MEMORANDUM OF FINDINGS

Subject: Requested PD Amendment, Sketch & Preliminary Plan
Case Files Z16-035, SUB16-050 & SUB16-051
Hess Ranch PD Amendment 1 and Filing 1 Sketch/Preliminary Plan ("The Trails At Crowfoot")
(First Submittal)

■ Sheet Number: L1.1

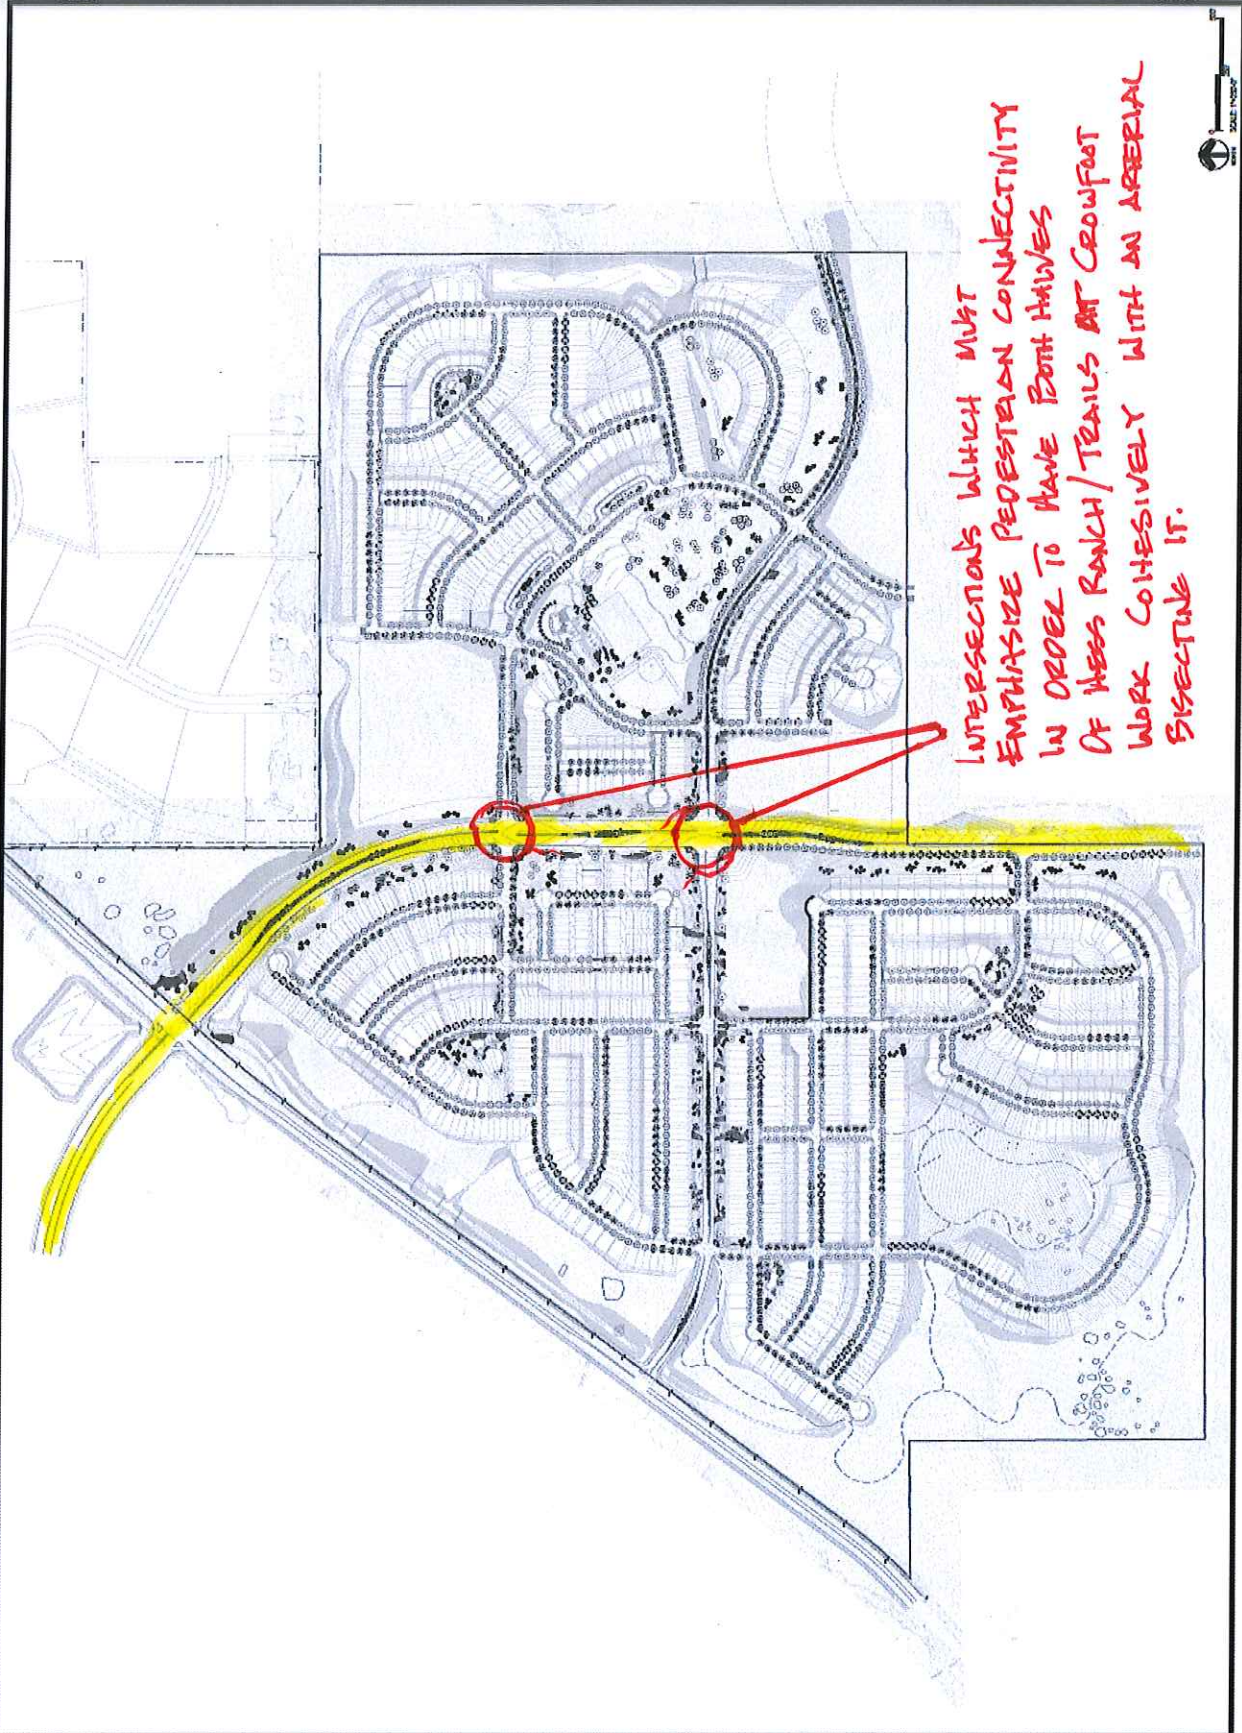
2. Hess Ranch/Trails at Crowfoot has an interesting challenge from a neighborhood planning perspective: It is bisected by a regional arterial roadway (Chambers Road) which is anticipated to carry large volumes of traffic. As such, the challenge is how to make both halves of the Hess Ranch/Trails at Crowfoot develop in a way where they cohesively interact. Staff believes that the key to this is at the pedestrian scale, particularly as it pertains to the two planned signalized intersections crossing Chambers Road. (See the attached map.)

As part of a resubmittal, staff would like the applicant to address how to make those intersections friendly for pedestrians with close up details of the methods the applicant intends to employ. This can include enhanced paving details to visually differentiate the crosswalk, comfortable pedestrian refuges at mid-street median crossing, landscape features at all four corners which mirror one another or extend a landscape theme around the entire intersection, enhanced landscaping within the medians, or other methods to make these intersections less of a psychology barrier at the pedestrian level and more of an opportunity to link both sides of Chambers Road together.

INTERSECTIONS WHICH MUST
 EMPHASIZE PEDESTRIAN CONNECTIVITY
 IN ORDER TO HAVE BOTH HAIVES
 OF WESS RANCH/ TRAILS AT CROWFOOT
 WORK COHESIVELY WITH AN AERIAL
 SYSTEM IT.
